CITY OF HANOVER
PLANNING COMMISSION MEETING
DECEMBER 17, 2018
AGENDA

SUBJECT: **Hanover Cove** for (1) Rezoning; (2) Planned Unit Development; and (3) Preliminary Plat

As requested, we have reviewed the revised Hanover Cove preliminary plat documents as prepared by Duininck, dated November 16, 2018, and we offer the following comments:

CHECKED BY: JVS	DRAWN BY: JVS
SCALE GRAPHIC	
DATE NOV 16, 2018	
SHEET DRAIN1

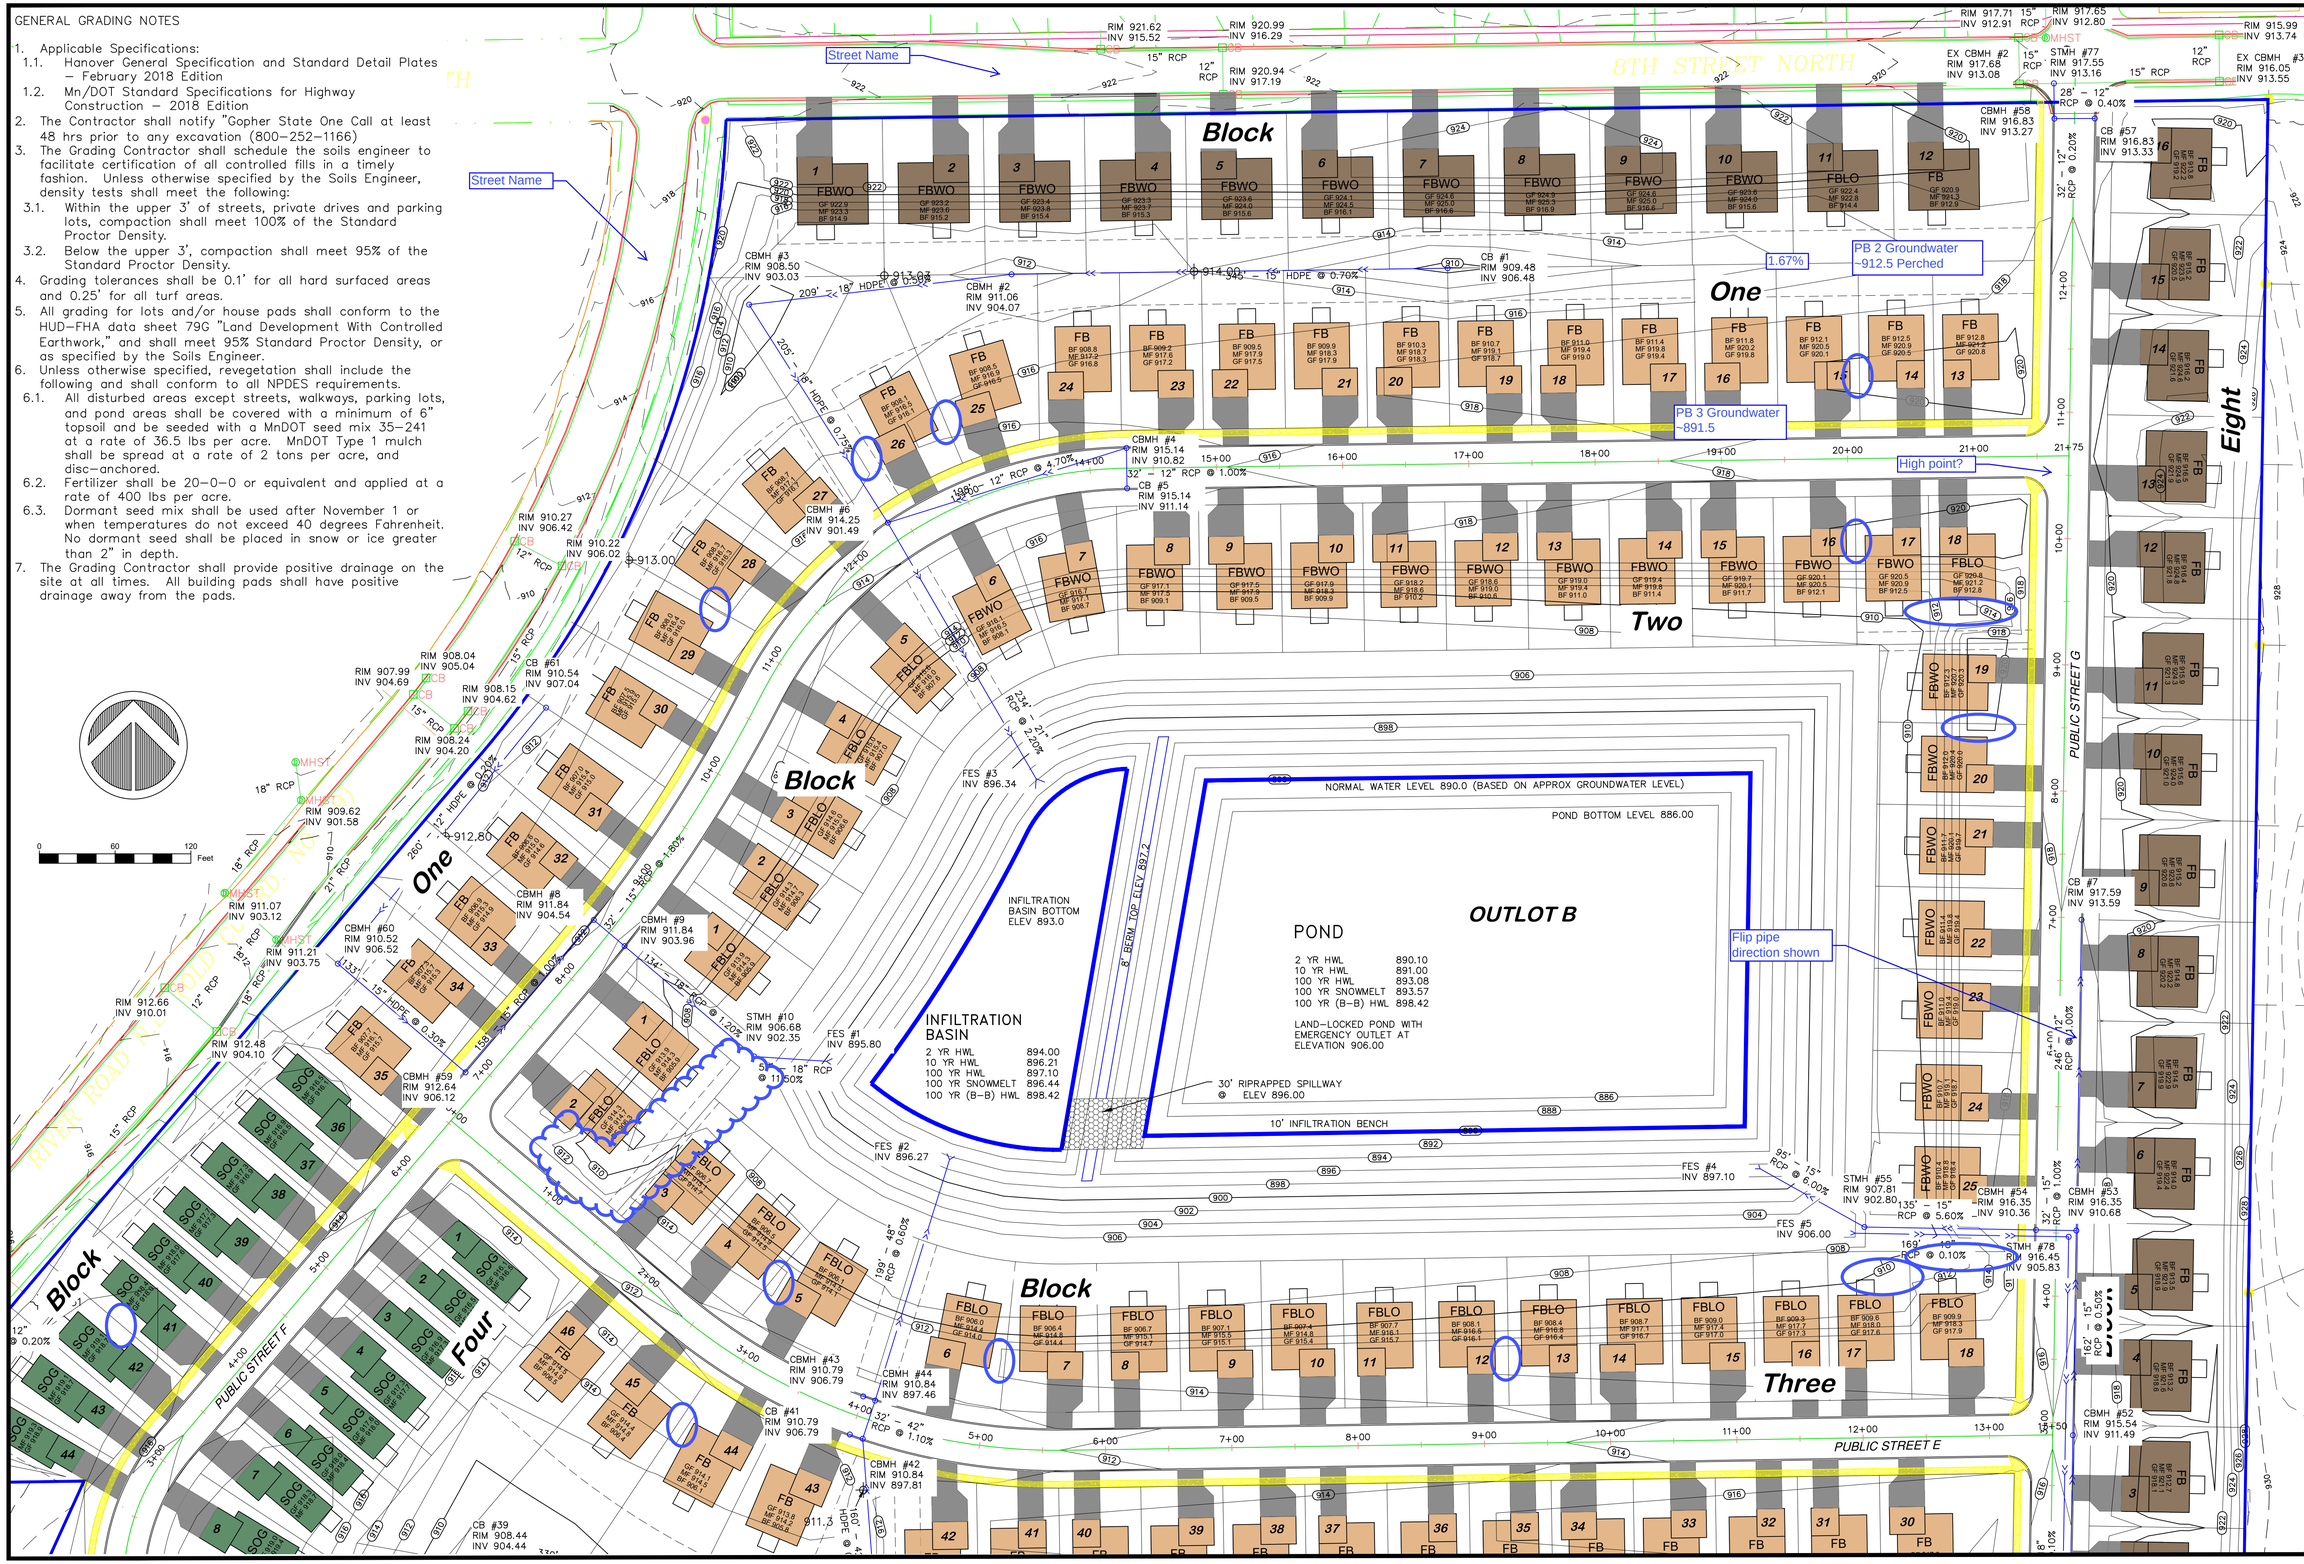
Grading and Drainage Plan Comments

1. Provide all street designations on all sheets (include River Road and 8th Street).
2. Provide driveway grades (consider adjacent sidewalks).
3. Provide flow arrows.

4. Provide all drainage and utility easements.
5. Provide high points and low points in the road.
6. Provide Lowest Opening Elevations for all 'lookout' lots.

9. The proposed contours do not always appear to agree with the elevation at the back of the proposed house type (e.g. Lots 17-47 Block 4, etc.). Revise as necessary.

10. Verify that drainage in the rear of Block 8 flows between the houses and not across the back of the lots necessitating additional drainage and utility easements.

11. See attached blue-lined plan sheets for locations of grading issues including the following;
    a. Several areas have drainage directed at building pads or the drainage from the building pad is unable to flow away and down the lot lines.
    b. Several areas have less than the required 2% minimum grade
    c. Several drainage swales are shown running across private property without drainage and utility easements

CHECKED BY: JVS	DRAWN BY: JVS
SCALE GRAPHIC	
DATE NOV 16, 2018	
SHEET SUB1

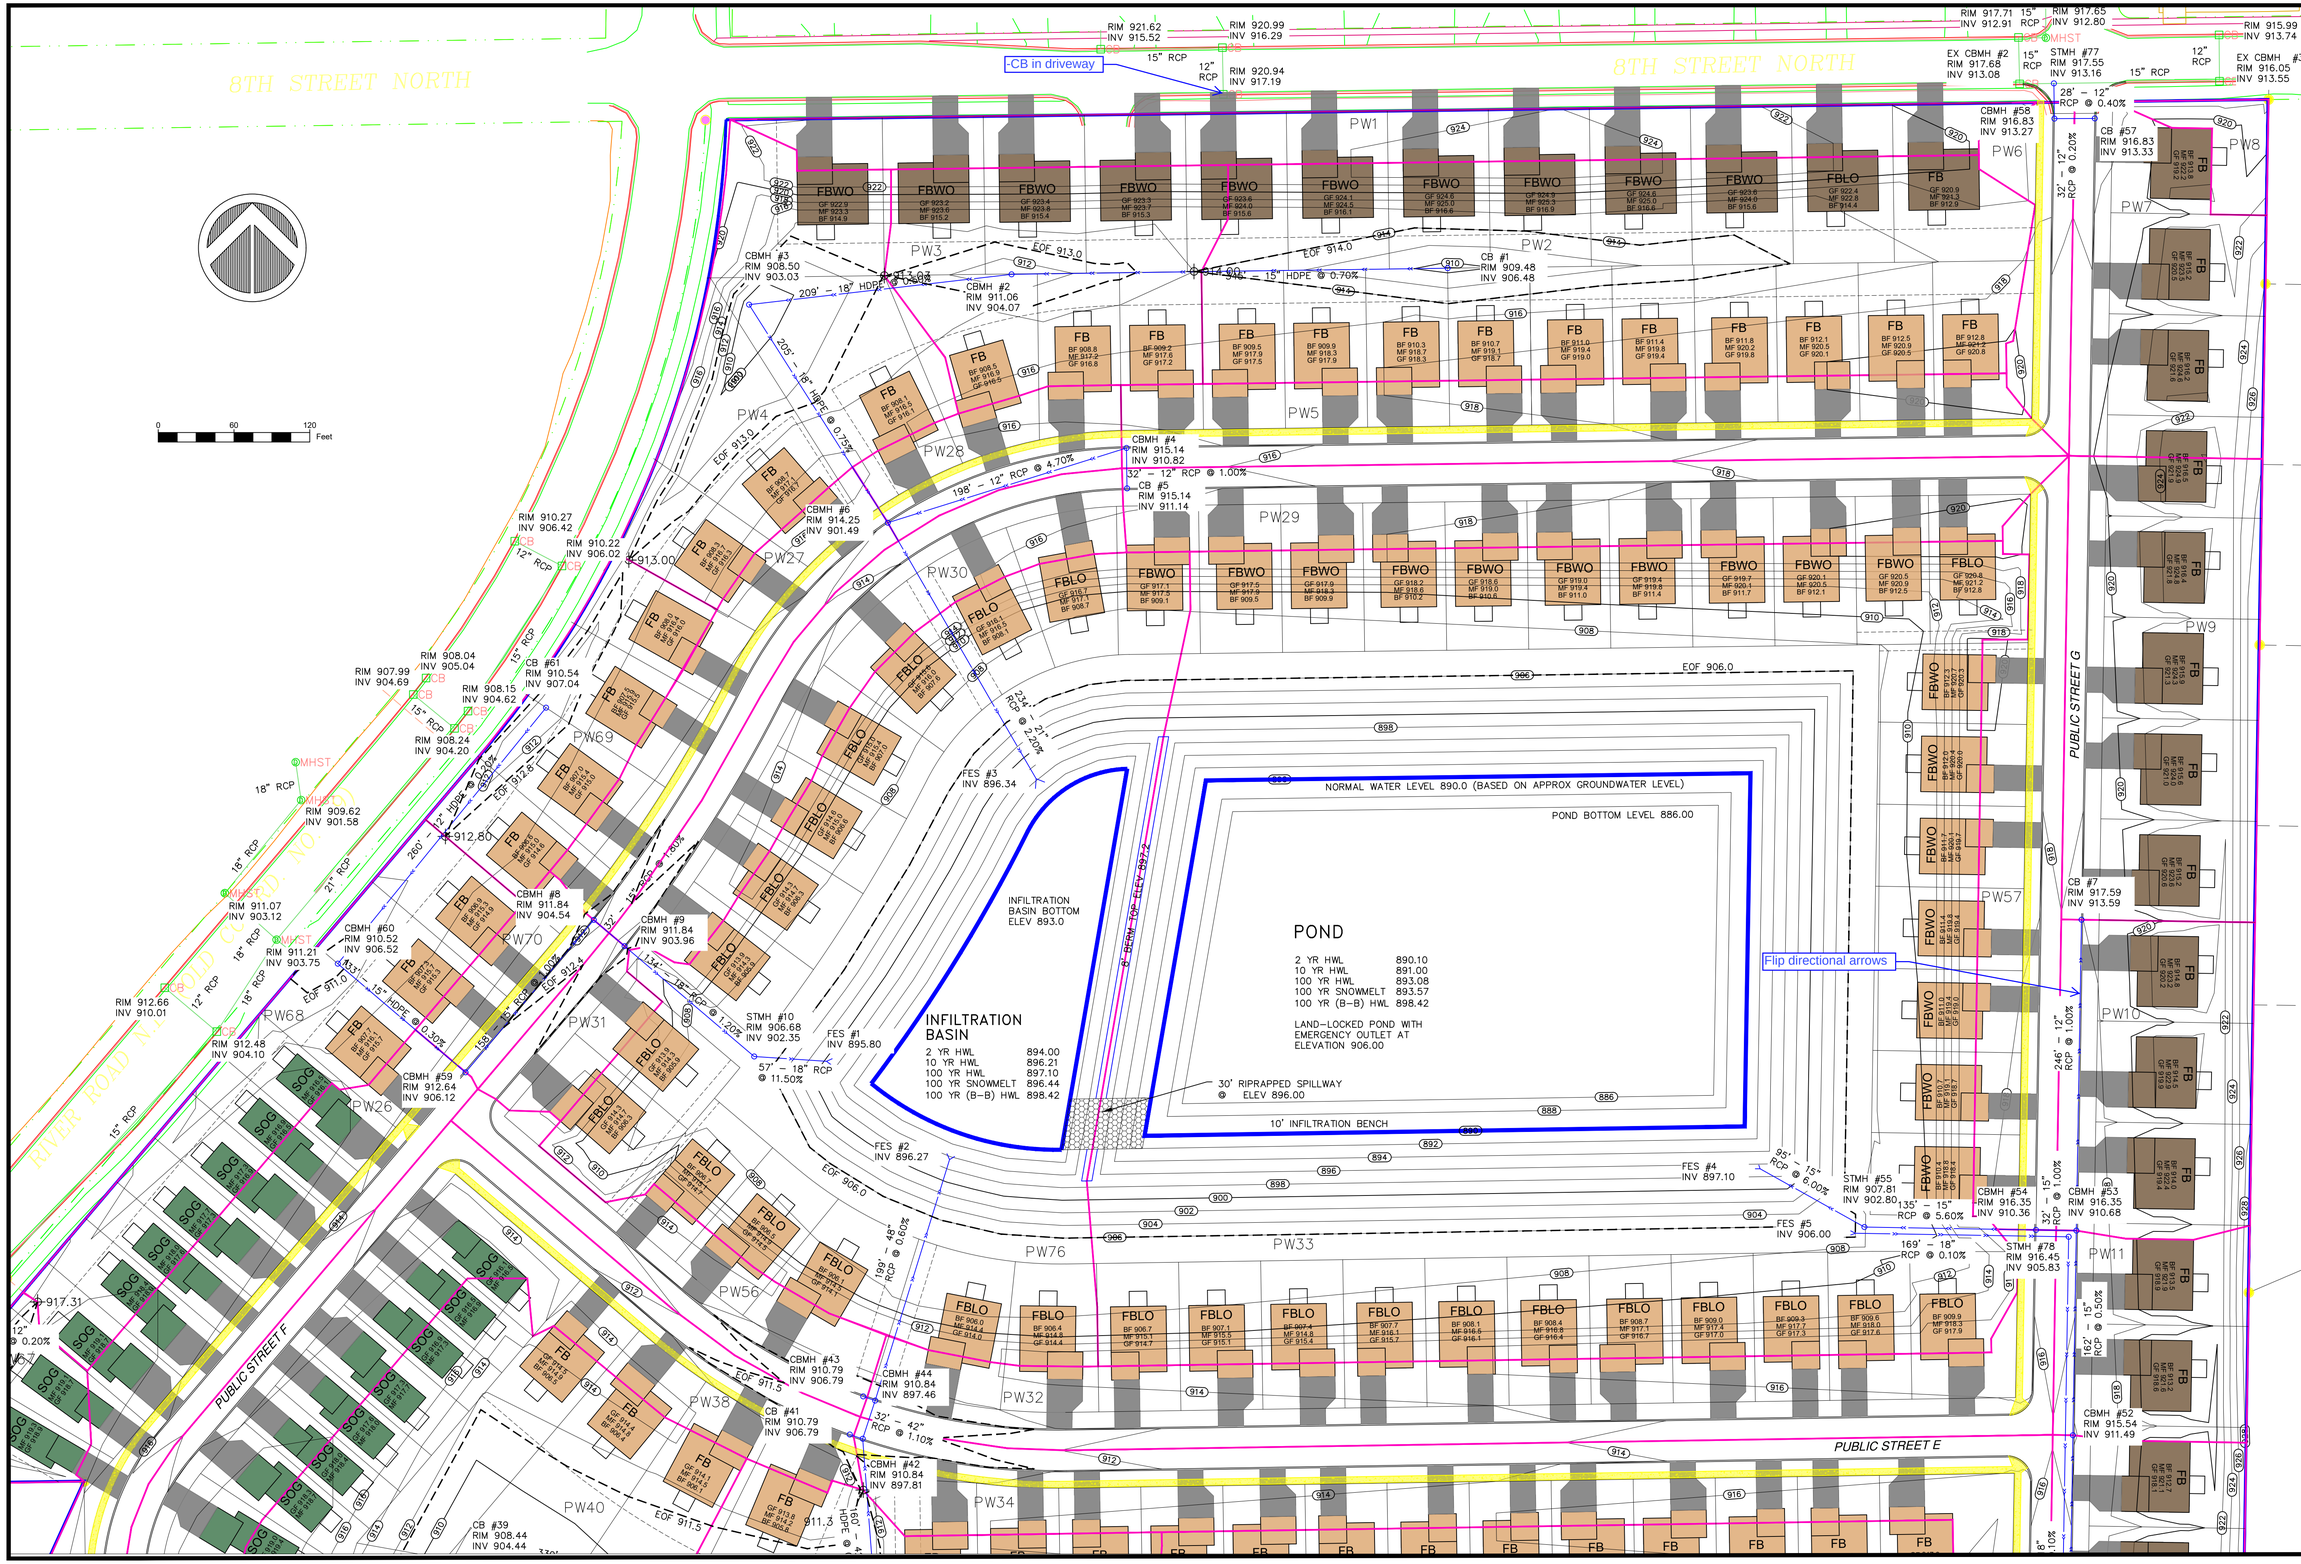
Subcatchment/Stormwater Plan Comments

1. Provide all street designations on all sheets (include River Road and 8th Street).
2. Provide 3' sumps to last accessible structures prior to ponds.
3. Provide draintile along the roadway at all low points.
4. There is an existing catch basin in conflict with the proposed driveway for Lot 5 Block 1
5. There is an existing catch basin in conflict with the turn lane on River Road.

CHECKED BY: JVS	DRAWN BY: JVS
SCALE GRAPHIC	
DATE NOV 16, 2018	
SHEET UTIL1

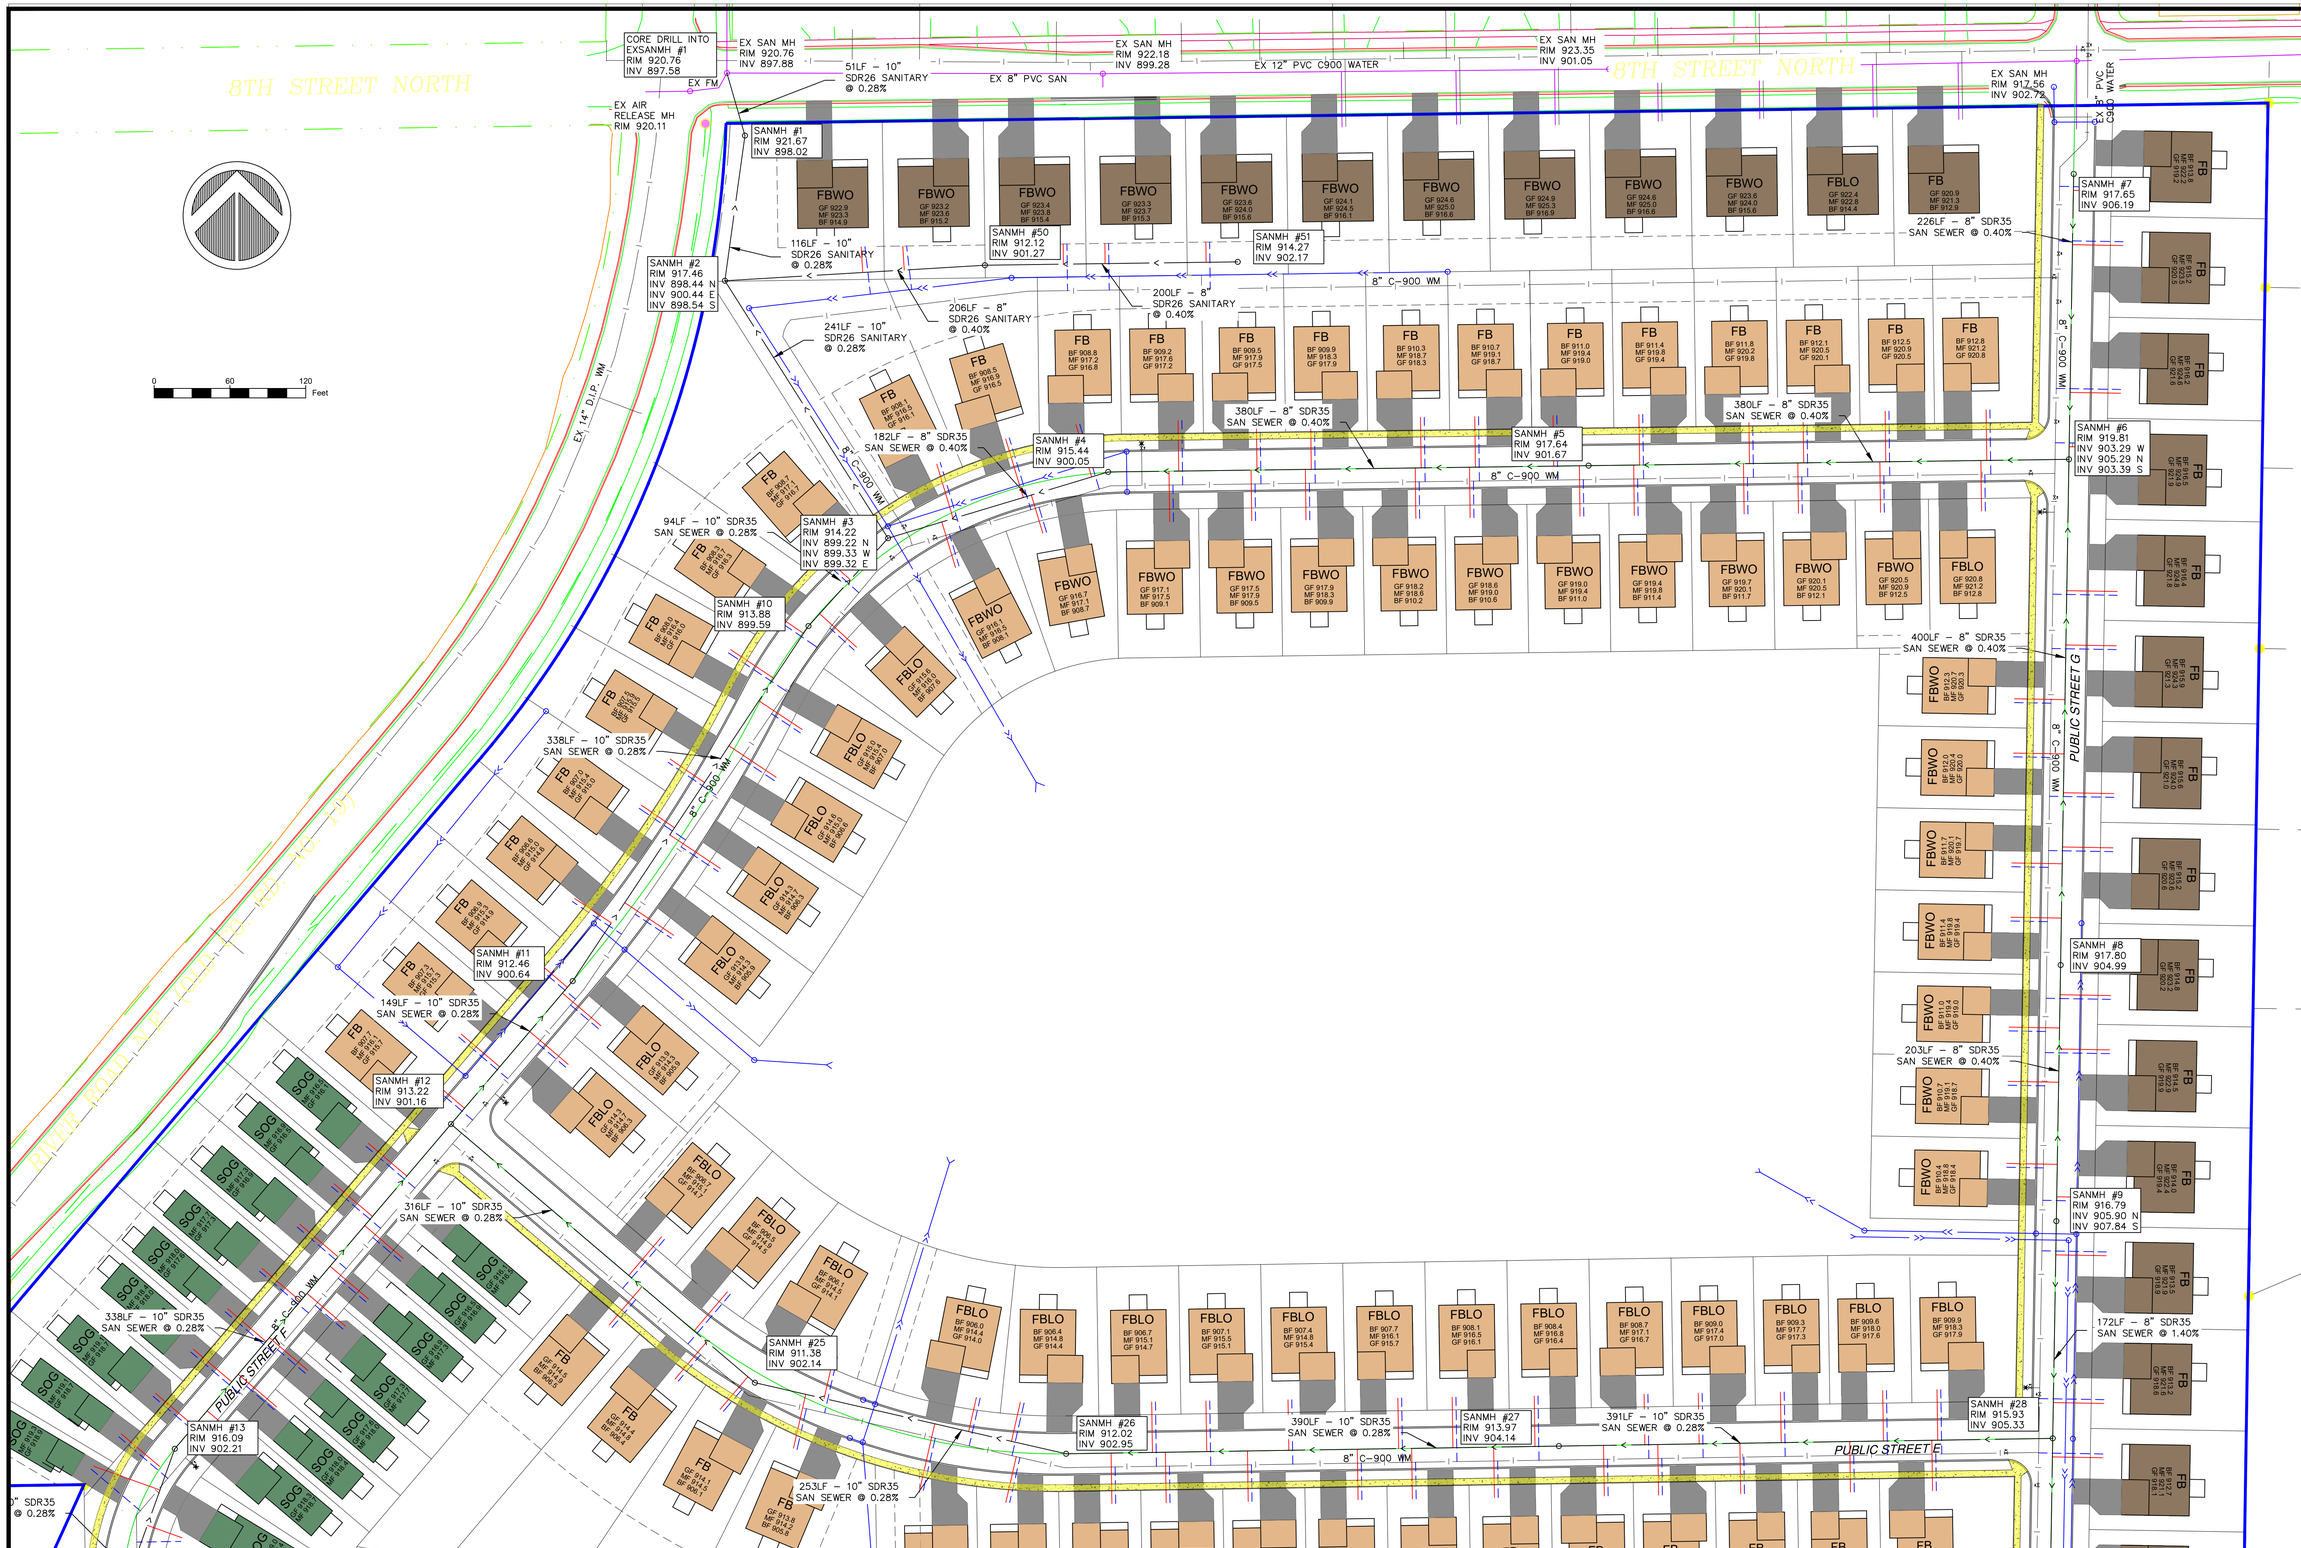
Utility Plan Comments

1. Provide all street designations on all sheets (include River Road and 8th Street).
2. Identify the locations where the proposed watermain connects to the existing watermain
3. Provide a plan that shows 250' radius circles to show fire protection covering the lots.
4. Provide additional hydrants to meet fire protection requirements as well as for flushing, air release, etc. as necessary
5. SDR 26 pipe would not need to be used from SANMH #2 to SANMH #50 to SANMH #51
6. SANMH #3, 18 and 25 are not on the centerline of the road
7. The utility services in the Public Street C cul de sac appear to be in conflict with one another. Consider revising
8. Sanitary services in the Public Street C cul de sac exceeding 75' will require a cleanout.
9. Note hydrant leads are ductile iron (see standard detail plate WAT-01).
